BOARD OF ZONING APPEAL

BZA Application Form

LOCATION OF PROPERTY: 18 Clinton St., Cambridge, MA

Raise the base of the foundation of rear portion of structure out of the high water table, resulting in an increase in Height of rear portion of the structure located within setbacks, requiring a special permit.

ELEVATION WEST -
REVISION

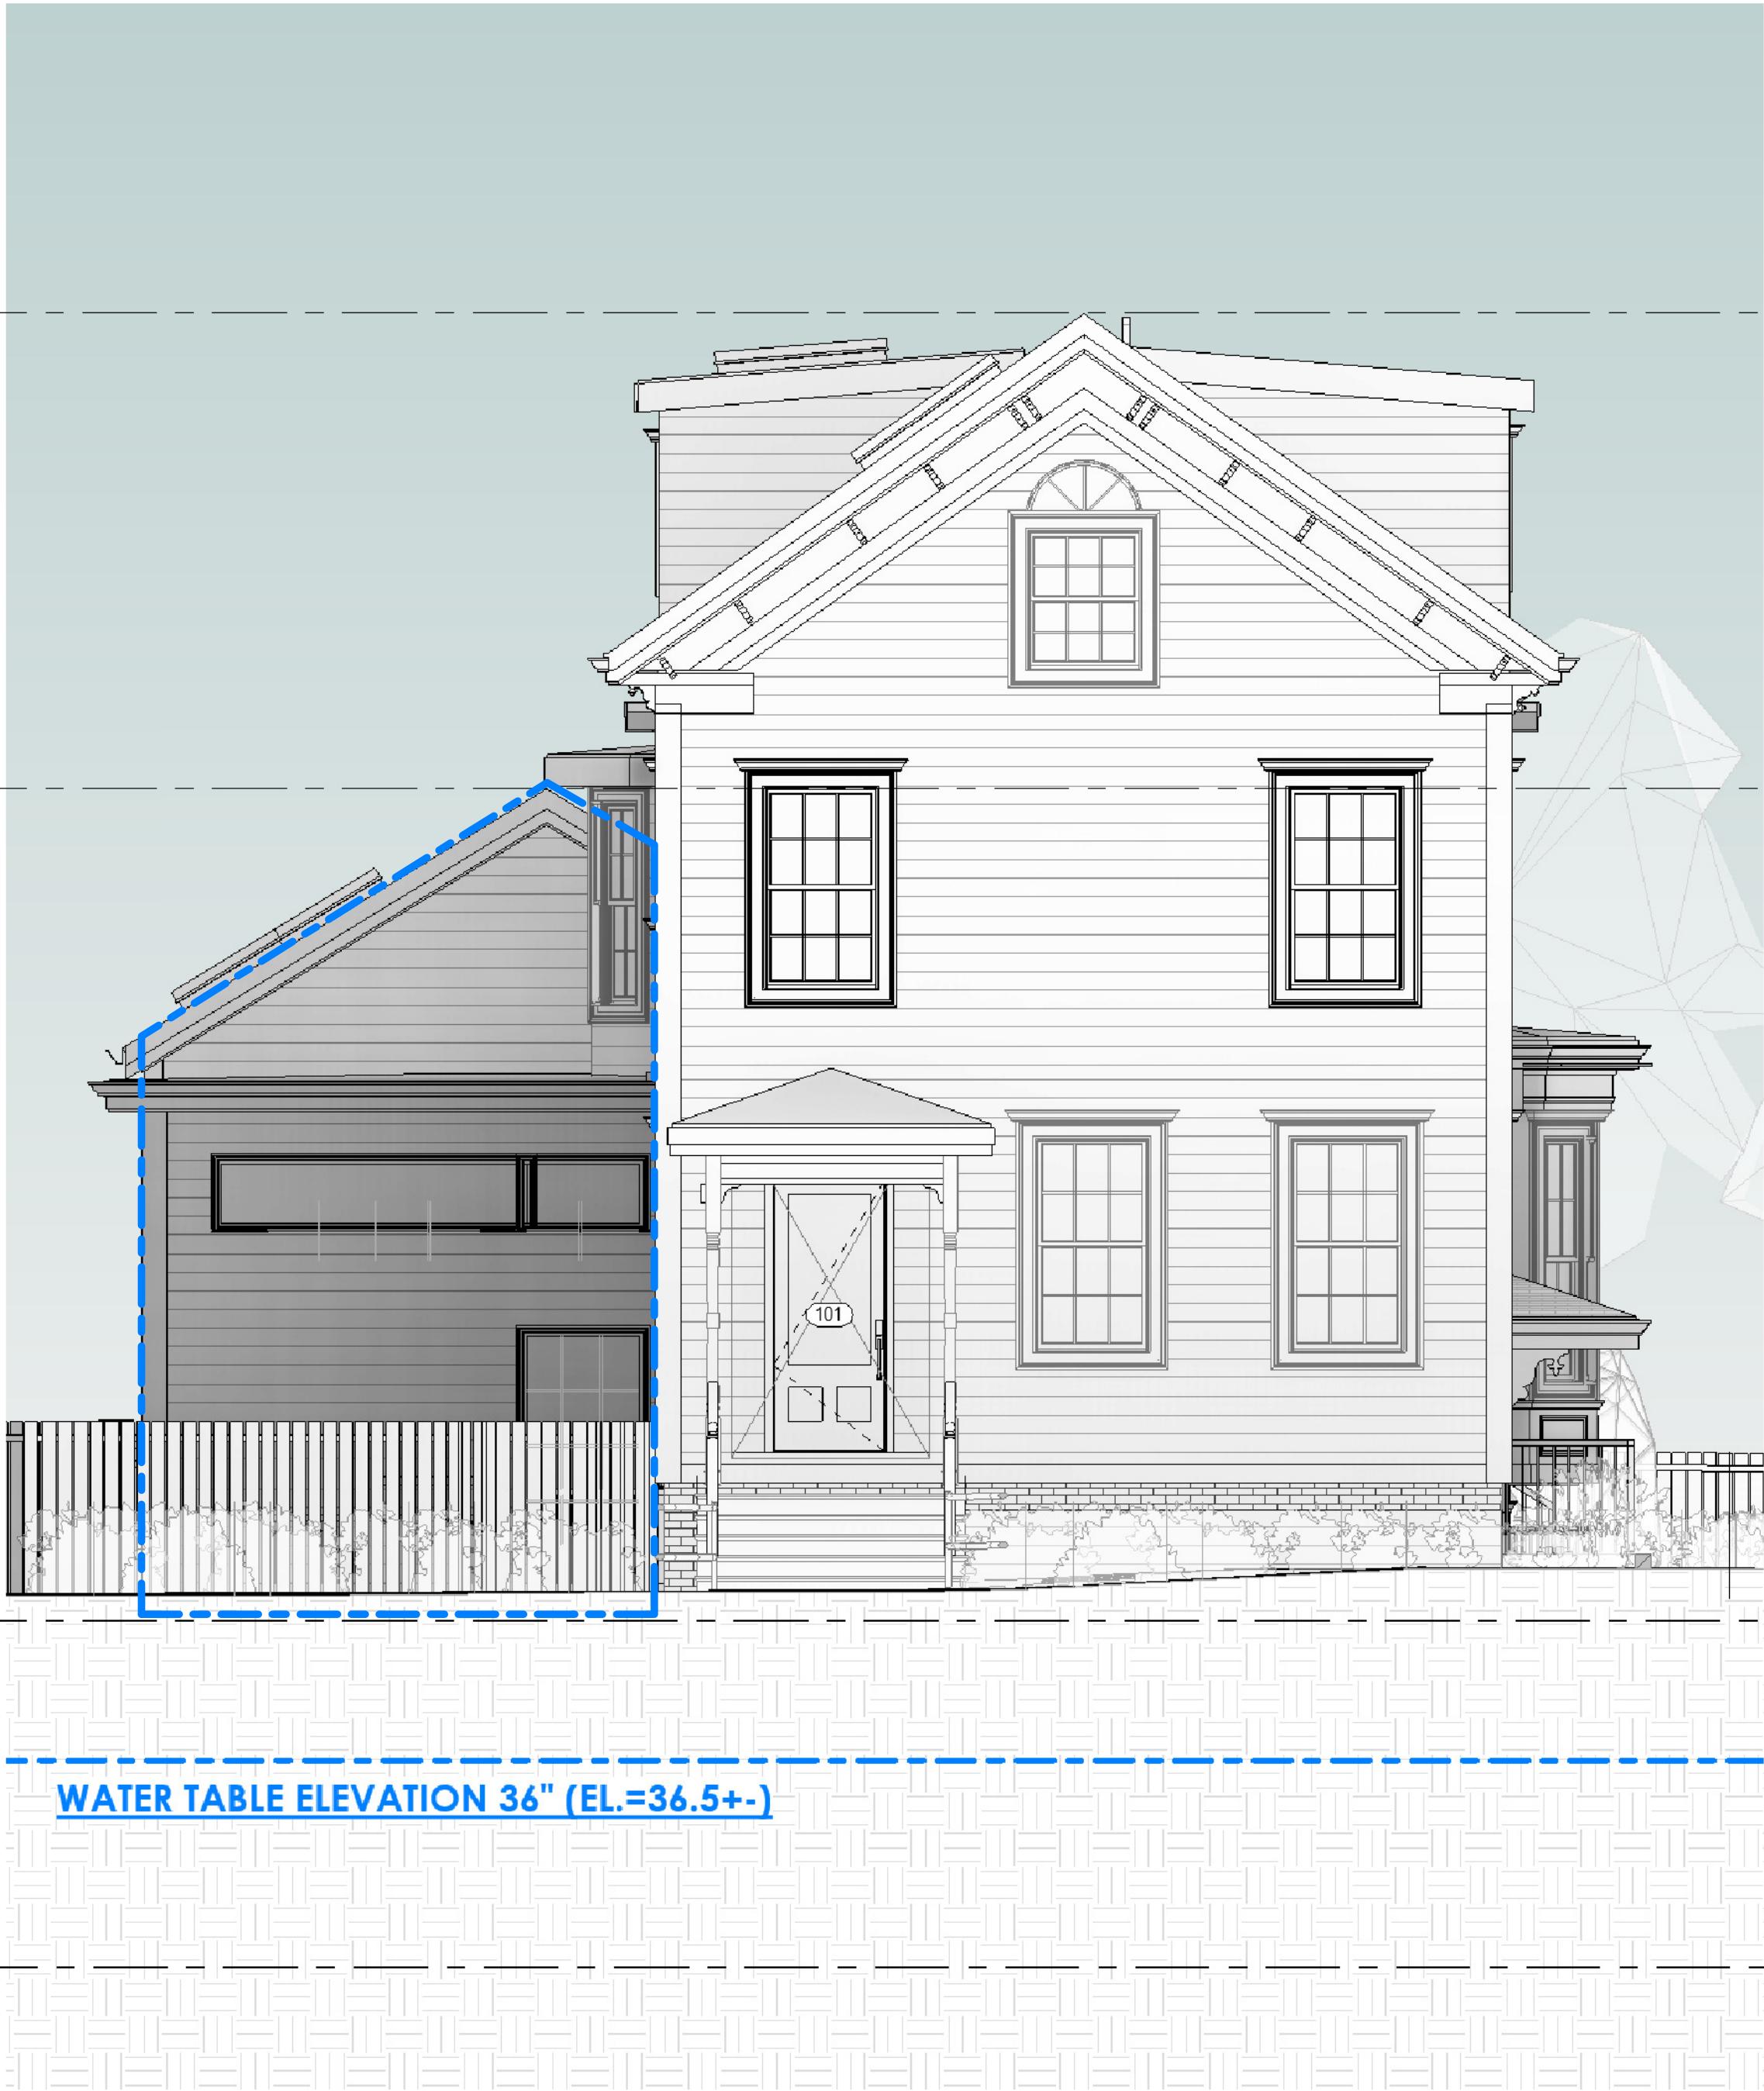
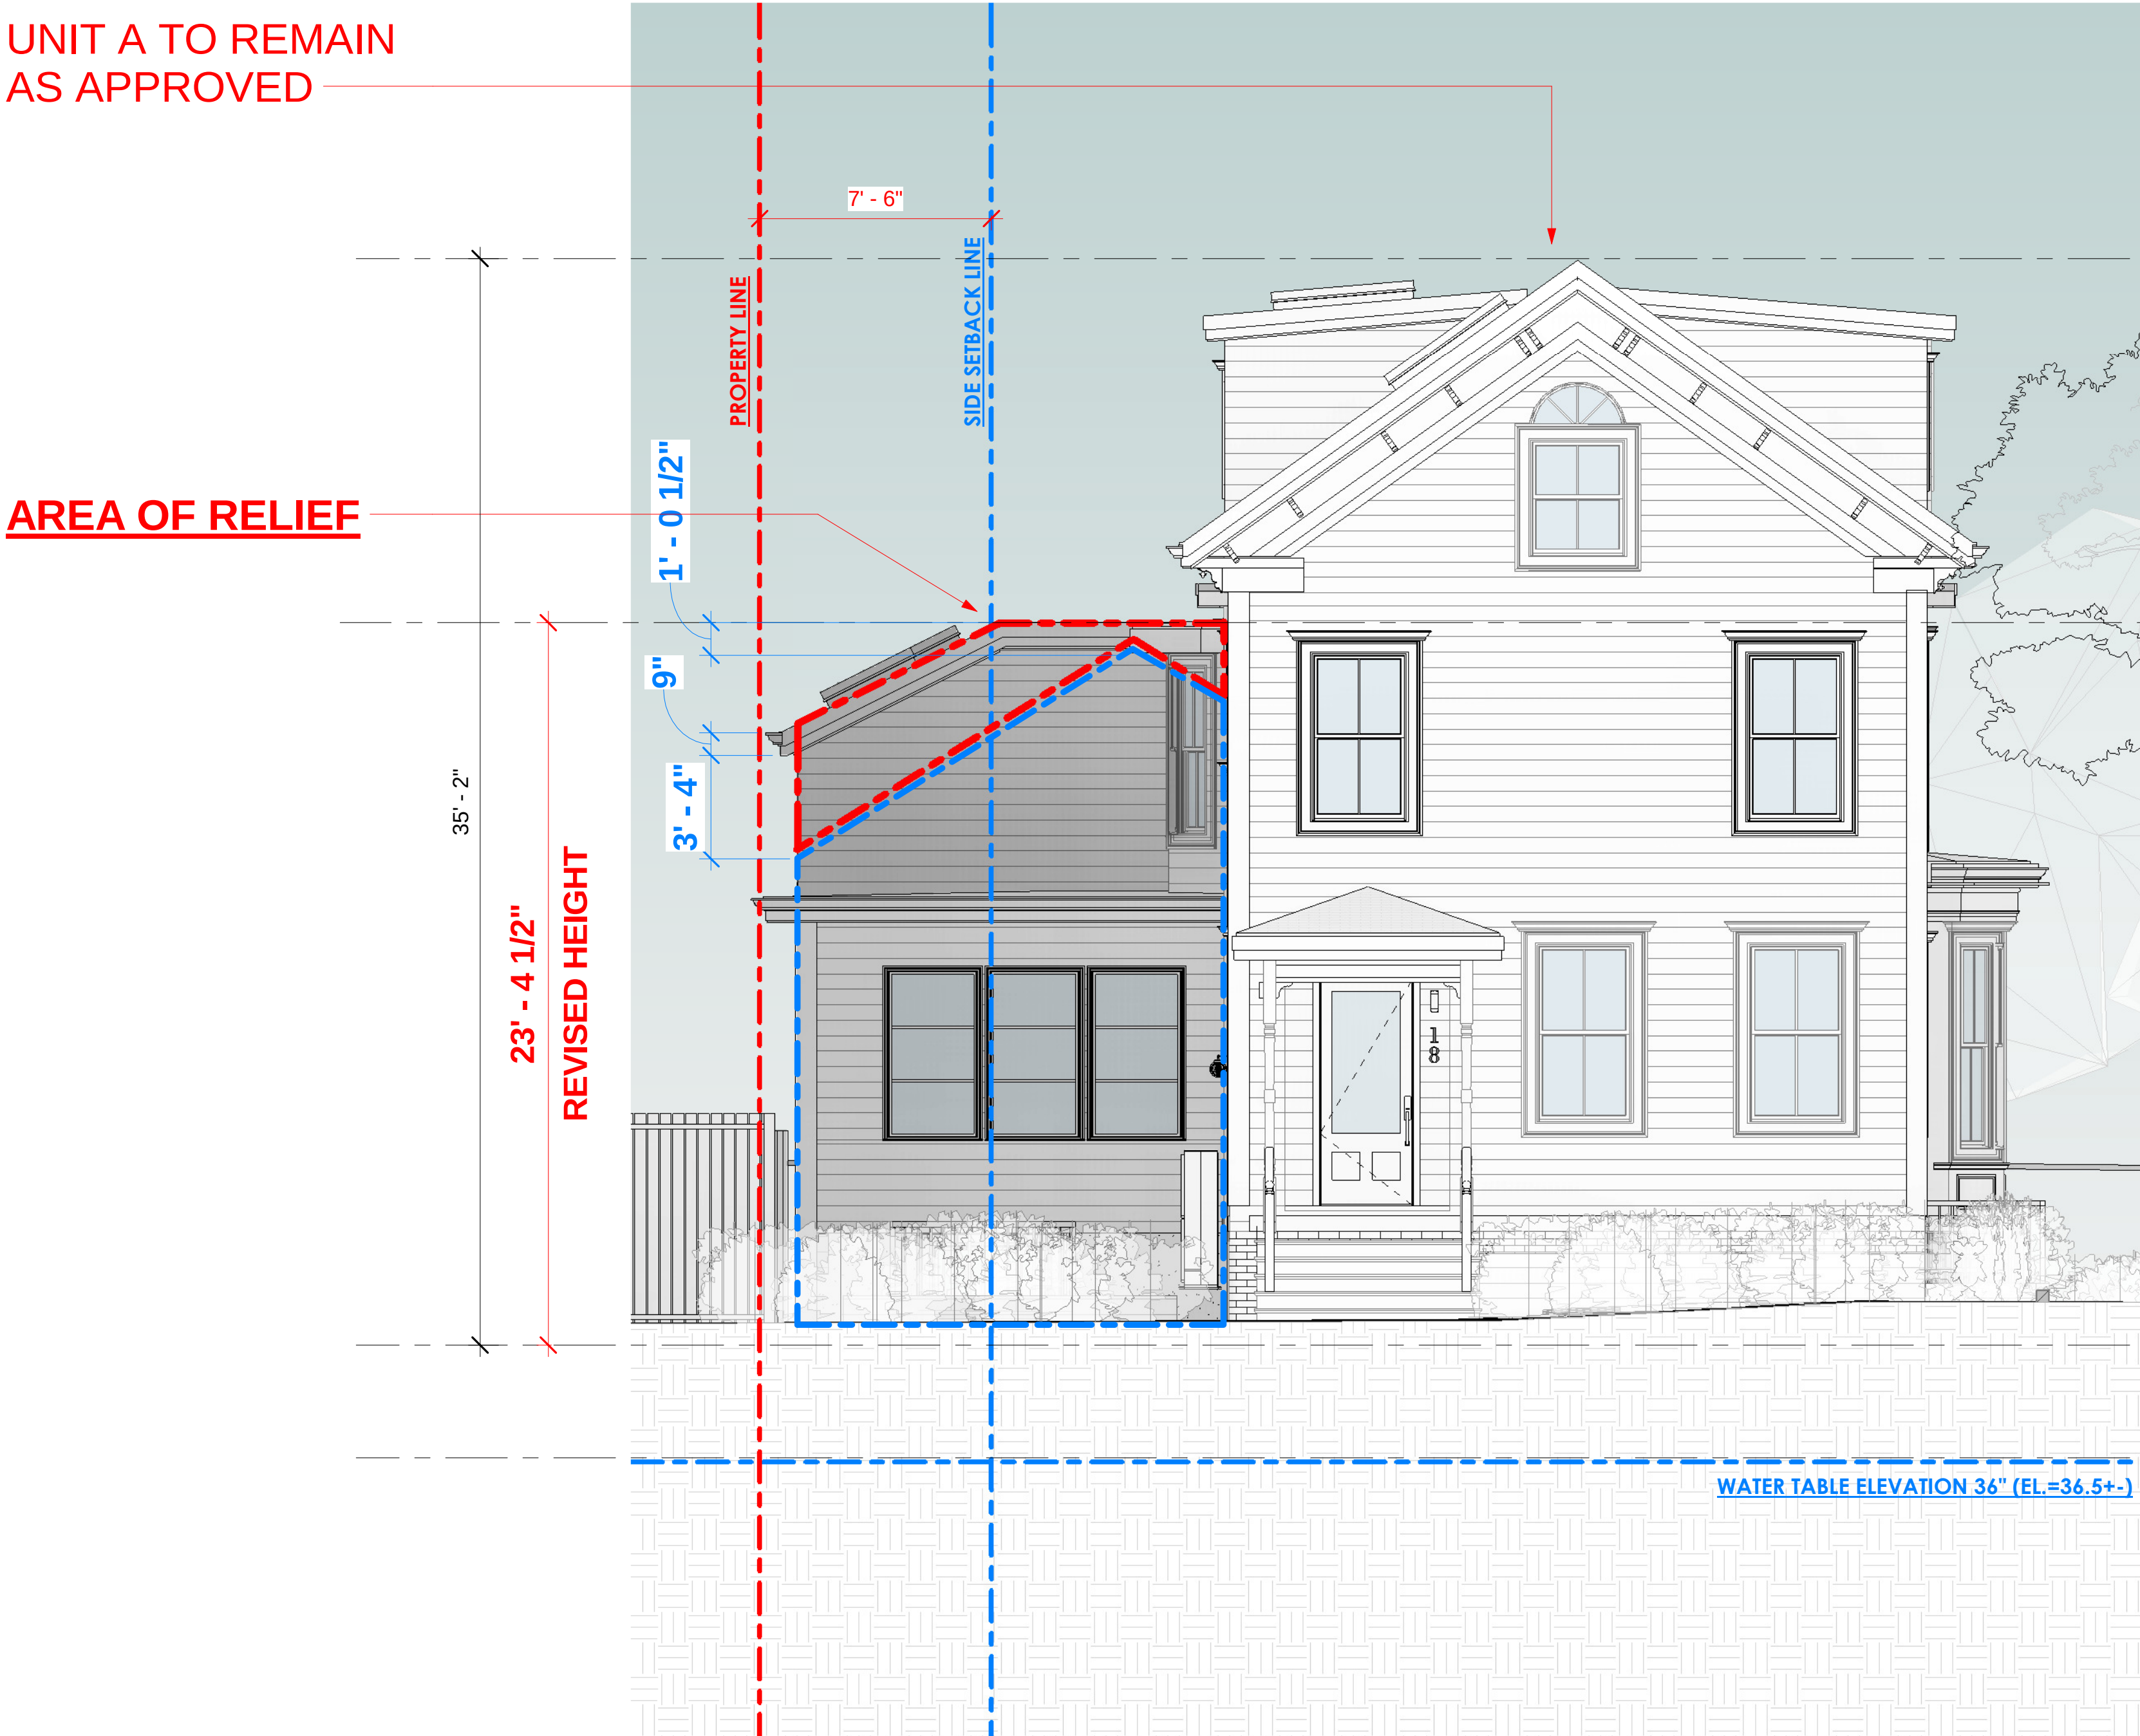
9 Oh, and by the way, this elevation you can see the
10 rear elevation as well. We had an eave as well, so that
11 really reduced the amount of the volume of siding on the
12 rear of the house. But I think we can see that in the next
13 sheet.
